UNITED STATES PATENT AND TRADEMARK OFFICE

Office Action Summary

09/159,775

DETAILED ACTION

F I G. 1

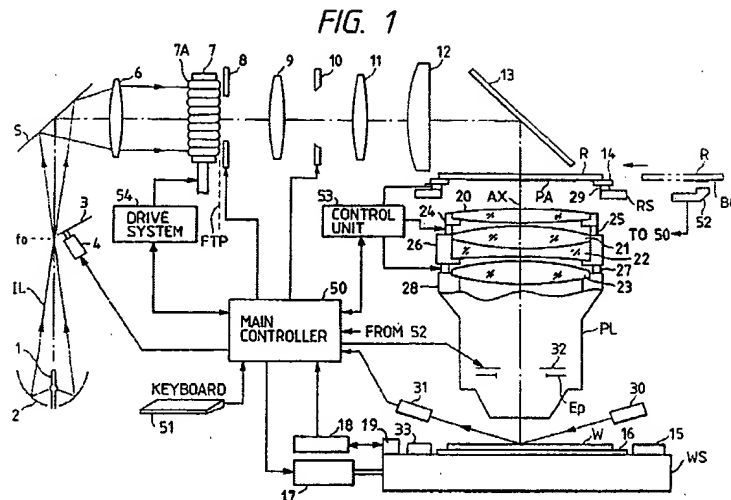
Taniguchi discloses an illuminator for illuminating an object with a luminous flux emitted from a light source, the illuminator comprising: an illumination system through which the luminous flux is projected onto the object (Taniguchi Fig 1) and Moriyama et al discloses a supporting unit coated with titanium for use in a projection aligner system which improves performance of the aligner. Therefore, it would have been obvious to a person of ordinary skill in the projection art at the time the invention was made to modify Yamada et al by combining Taniguchi and Moriyama by substituting the supporting unit coated with titanium of Moriyama et al in the projection aligner of Taniguchi because it improves performance of the aligner system as suggested by Yamada et al (Yamada et al Col 1).
